U.S. Army Corps of Engineers Information Needs – June 2009

Preparation for Bellefonte Units 3 and 4 Corps of Engineers Site Visit, July 8-10, 2009

COE INFORMATION NEED: COE-2

COE INFORMATION NEED: COE-3

FIGURE 2.1-1
Site Plot Plan

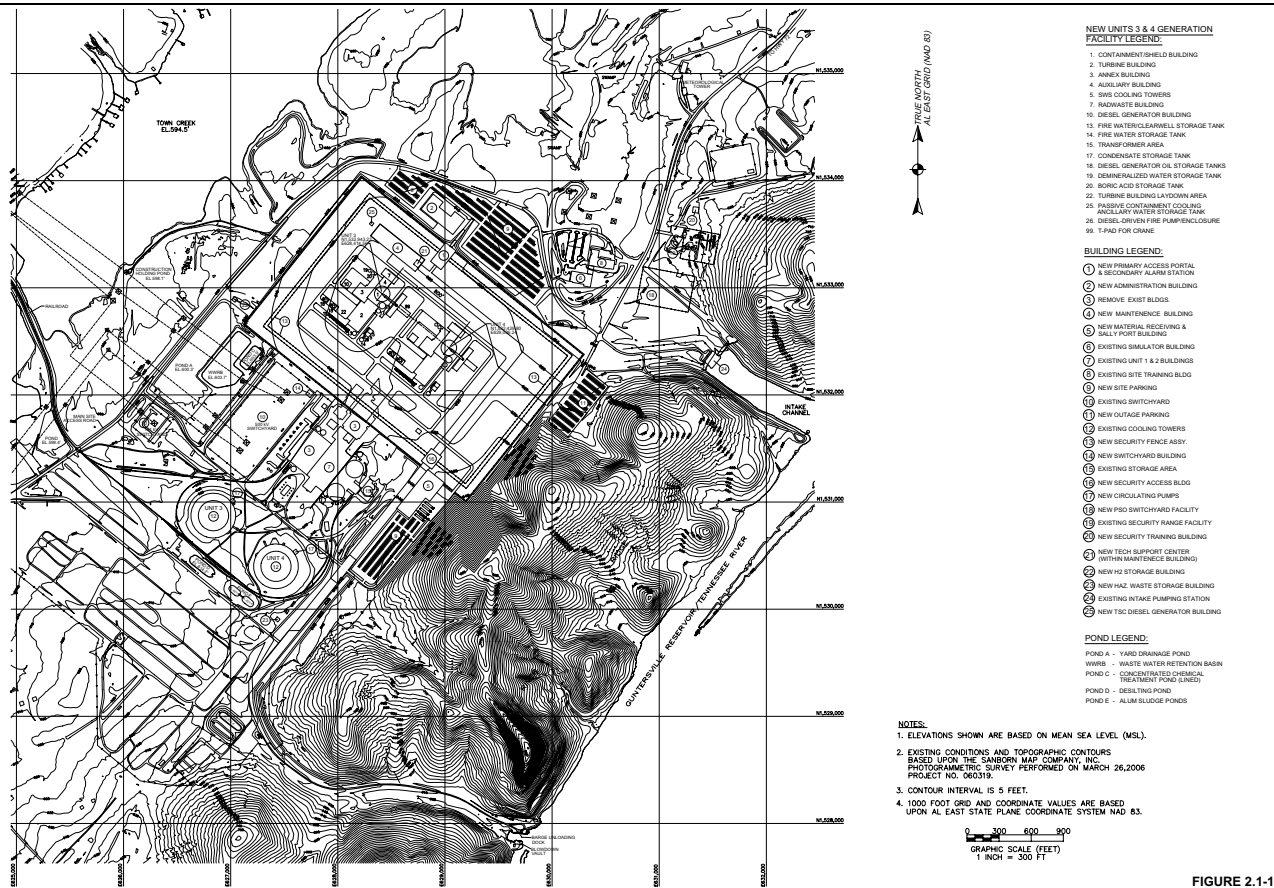
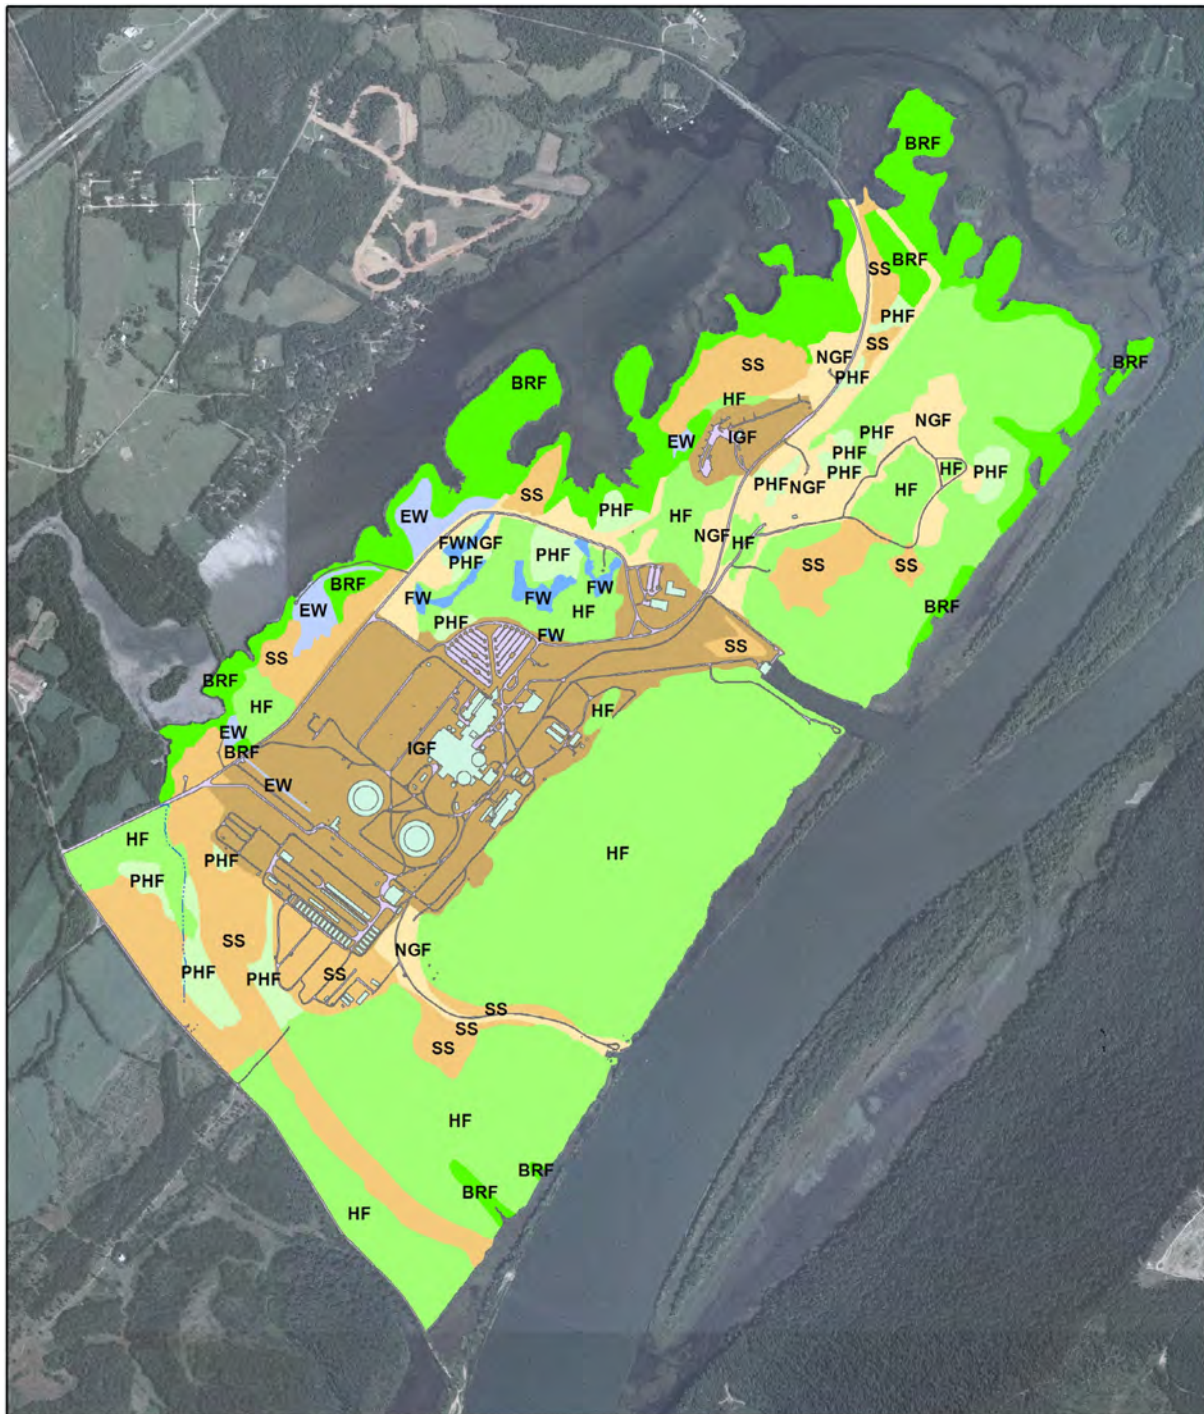
Provide an SME and supporting data and information to discuss plans for dredging or other activities to clean out barge slip and intake canal including alternative dredge methods, planned configurations and depths and frequency. Discussion should include:

- Discharge of dredged or fill material into wetlands or waterways,
- dredging performed during construction of Units 1 and 2 including mussels and aquatic organisms observed,
- alternative dredge material disposal sites, recycle options, and treatment/reuse alternatives,
- methods to minimize dredging and construction related turbidity.

BLN ER Figure 2.1-1, Site Plot Plan, illustrates the location of the intake canal, barge dock, and blowdown discharge.

FIGURE 2.4-1
BLN Vegetation Coverage

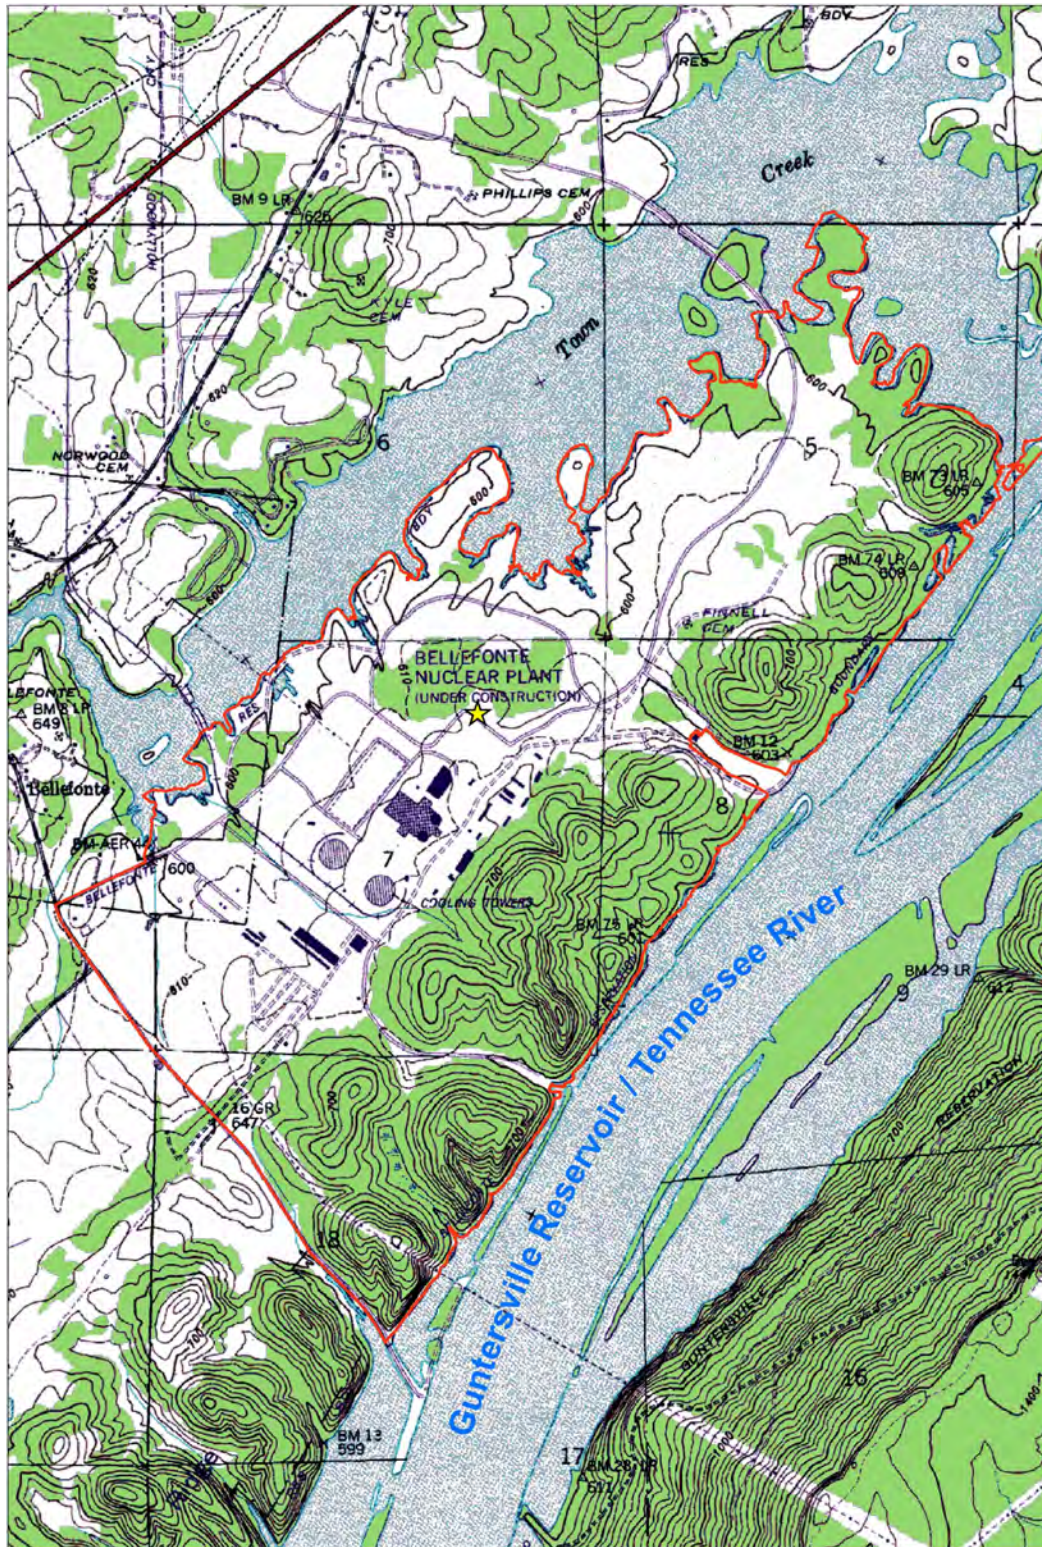
Provide an SME to discuss the wetland investigations that have been performed at the site and be prepared to discuss topics such as:

- Has the entire site been surveyed,
- wetlands found on the site both in the proposed construction foot print and in areas outside the footprint,
- how the recommendations of the May 2006 report (Request #10389 – Bellefonte NP – Wetlands Site Visit: Wetland Input) were investigated and considered in the on site alternatives analysis for construction of Bellefonte Units 3 and 4 for avoidance and minimization of environmental impacts,
- the process TVA has used to demonstrate that the locations selected for BLN units 3 and 4 are the least environmentally damaging practicable alternative (LEDPA), and that other site configurations would result in greater damage
- why the proposed units cannot be situated outside wetlands.

Provide maps of the survey areas to support the discussion.

TVA confirms that the entire site has been surveyed for wetlands.

Figures 2.4-1 (BLN Vegetation Coverage), 2.4-2 (BLN Topographic Map), and 2.4-3 (BLN Special Habitats) illustrate wetland areas and site topography, and are provided as attachments.
